## ENVIRONMENTAL IMPACT REPORT

Project No. 180357  
SCH No. 2010091079

**SUBJECT:** **THE WATERMARK**. GENERAL PLAN AMENDMENT, COMMUNITY PLAN AMENDMENT, REZONE, VESTING TENTATIVE MAP, PLANNED DEVELOPMENT PERMIT, CONDITIONAL USE PERMIT and a STREET VACATION to change the current land use designation from Industrial/Business Park to Commercial/Residential Prohibited and remove the Prime Industrial Lands identification on a portion of the project site, a rezone of a portion of the project site from IP-2-1 to CR-2-1 to construct a mixed-use development comprised of commercial office space, commercial retail space, and a movie theater. The Street Vacation is required to vacate Scripps Gateway Court. In addition to new development, the proposed project includes existing development that is occurring on the project site in accordance with existing/previous project approvals, including an approved CUP, Planned Industrial Development (PID) Permit, and Planned Development Permit (PDP) (CUP/PID No. 991027; CUP No. 174323/PDP No. 174234 Extension of Time). The 34.39-acre project site is located at 10137 Scripps Gateway Court and is designated Industrial/Business Park and the IP-2-1 zone with

Figure 4-1. Proposed Multi-Use Path

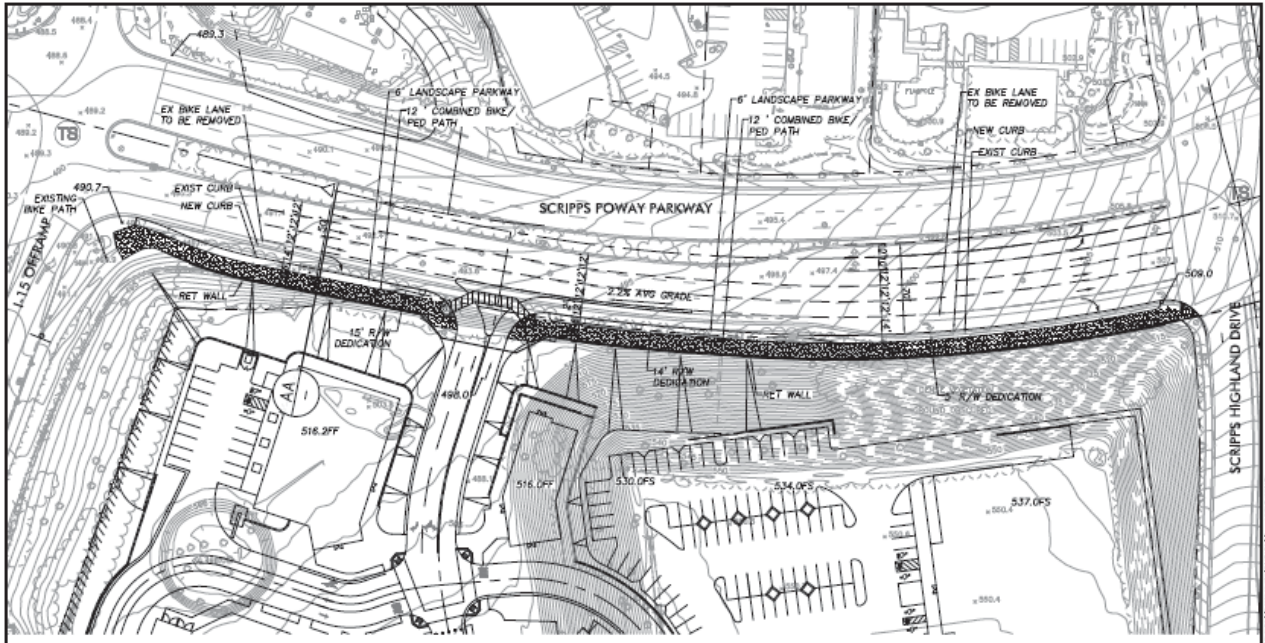
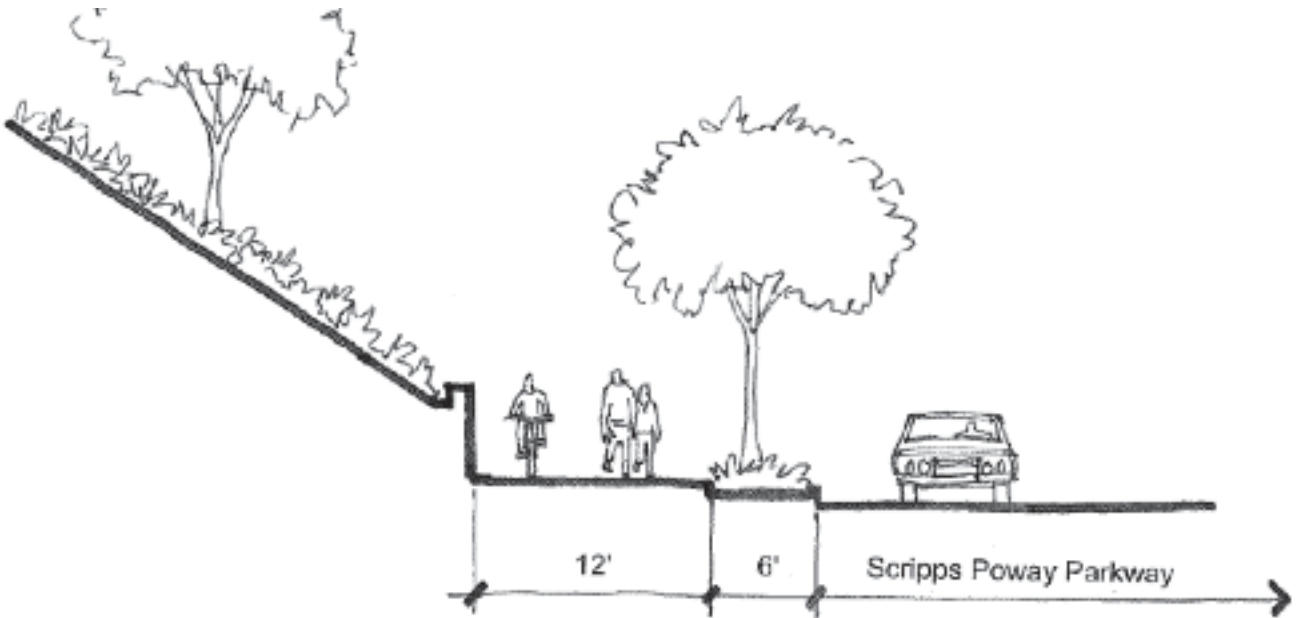
- The removal of the bike lane on Scripps Poway Parkway is not supported by Caltrans. The addition of the bike path on Scripps Poway Parkway does not absolve all conflict between non-motorized users and motor vehicles. The intent to remove bicycle traffic from eastbound (EB) traffic lanes on Scripps Poway Parkway in lieu of having bicyclists use the proposed path will not remove all bicyclists from eastbound lanes on Scripps Poway Parkway. Many experienced bicyclists will continue to take the outside lane on Scripps Poway Parkway, rather than use the proposed path. Forcing bicyclists to use the path would require them to negotiate the conflicts at the ingress and egress to the Project, as well as freeway off-ramp traffic turning right from the NB I-15 off-ramp. The project should appropriately identify the impacts to bicyclists and pedestrians. It is assumed as part of Caltrans review that the City of San Diego's TSW/Transportation Engineering Operations, Multi-Modal Program has reviewed any proposed changes to the non-motorized circulation as they relate to this project.

**B-16** Comment Noted. Based on an examination of the proposal for a channelized right-in/out-access point on Scripps Poway Parkway, a 12-foot non-contiguous bike/pedestrian path was determined to provide protection to bicyclists while serving to help eliminate the conflict of traffic weaving between right turn lanes and thru lanes on Scripps Poway Parkway. As a result, the existing bike lane on Scripps Poway Parkway in the eastbound direction will be removed and replaced with the bike/pedestrian path as shown in Figure 4-1 and Figure 4-1 of the EIR.
